GE Hitachi Nuclear Energy

MFN 09-697

Subject: **Response to Portion of NRC Request for Additional Information
Letter No. 377 Related to ESBWR Design Certification Application –
Fuel Pools – RAI Number 9.1-128**

RAI Number 9.1-128

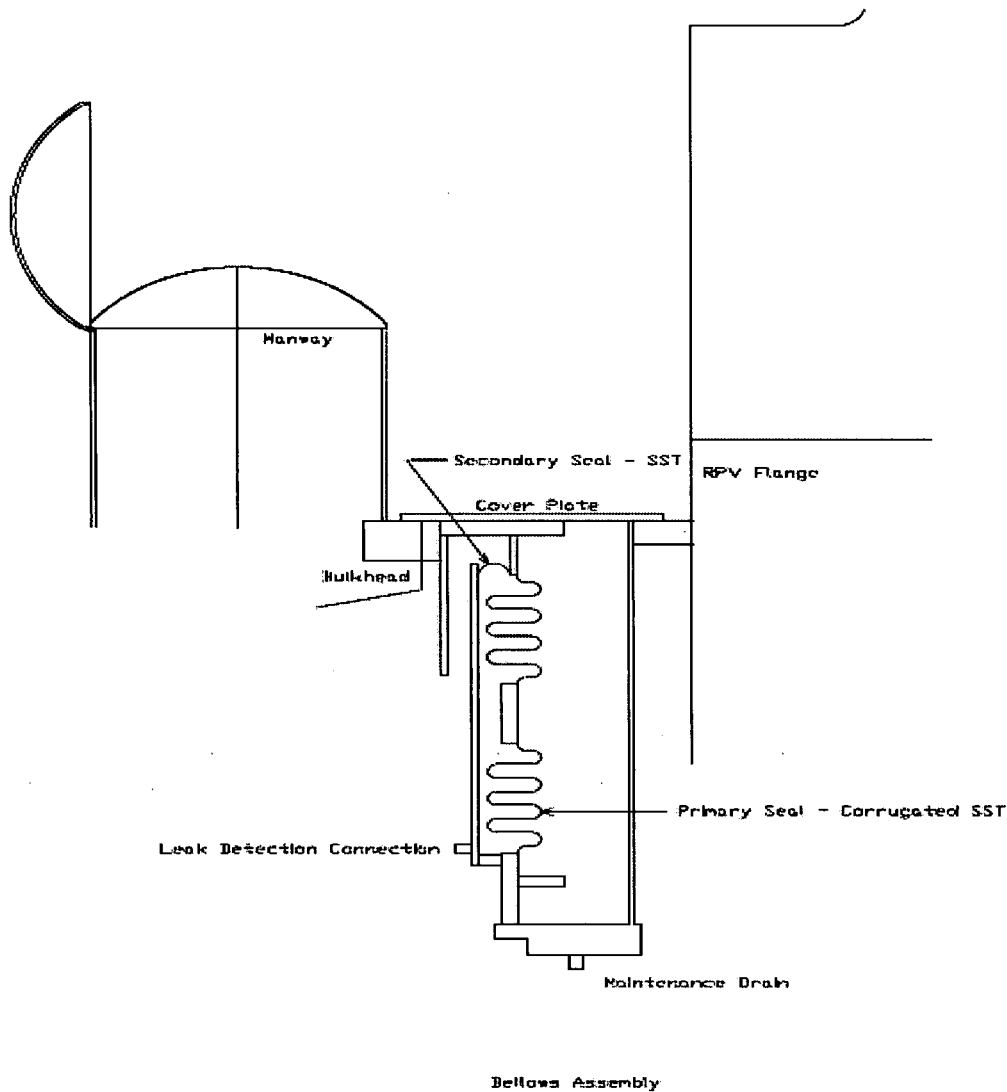
Applicants for standard design certifications are required by 10 CFR 52.47(a)(22) to address operating experience insights. Inspection and Enforcement (IE) Bulletin 84-03, "Refueling Cavity Water Seal," was issued to address the potential failure of refueling cavity seals to assure that fuel uncover during refueling remains an unlikely event. The bulletin required licensees to evaluate the potential for and consequences of a refueling cavity water seal failure. Additional information concerning refueling cavity seal failures was provided by Information Notice (IN) 84-93, "Potential for Loss of Water from the Refueling Cavity." IN 84-93 also noted that refueling cavities can be drained due to failures associated with other seals and as a consequence of valve misalignments. Therefore, in order to adequately address operating experience considerations and in accordance with the requirement specified by 10 CFR 52.47(a)(22), the following additional information is required:

- a. Describe the design and installation of the refueling cavity seal and any other seals that will be used and whose failure could cause the refueling cavity to drain.*

- b. For each of the seals identified in (a), describe measures that will be implemented to ensure that the seals remain intact and do not become degraded over time.*

- c. For each of the seals identified in (a), evaluate the potential for and consequences of seal failure. These evaluations should address the following considerations:*

- a) Design of the ESBWR refueling bellows will not vary in concept from the bellows assemblies currently in service in the GE BWR operating fleet, as operating experience has demonstrated this design to be robust with no history of significant failure. The bellows assembly is a permanent installation, unlike some bellows designs that are only installed for refueling. All bellows assembly components are steel, with the actual bellows seals fabricated from 316L stainless steel for corrosion resistance. As seen in the figure below, the bellows primary seal is corrugated and extends from the lower flange of the reactor vessel to the interior of the reactor cavity. All the component connections in the design are welded, and leakage can only occur if there is a through wall defect.

This design facilitates vessel movement due to thermal expansion. The entire refueling bellows assembly is located below the reactor vessel flange such that it cannot interfere with removal of core components for refueling. Normally closed drains on the wet side of the bellows are provided to support maintenance. A spring loaded secondary seal is provided to prevent leakage into the drywell in the event a leak occurs through the primary seal.

- b) As seen in the figure above, cover plates are provided for the bellows, which protect against anything (e.g., fuel assembly) that may be dropped during refueling. The cover plates remain in place during operation. The bellows are installed vertically beneath a plate welded to the bulkhead, which provides further protection in the event the cover plates are removed for cleaning or inspection. The bellows supplier shall provide guidance for routine maintenance and inspection of the bellows. The refueling bellows seals are fabricated from 316L stainless steel for corrosion resistance. Normally open leak detection connections are located on the dry side of the bellows for continuous monitoring.
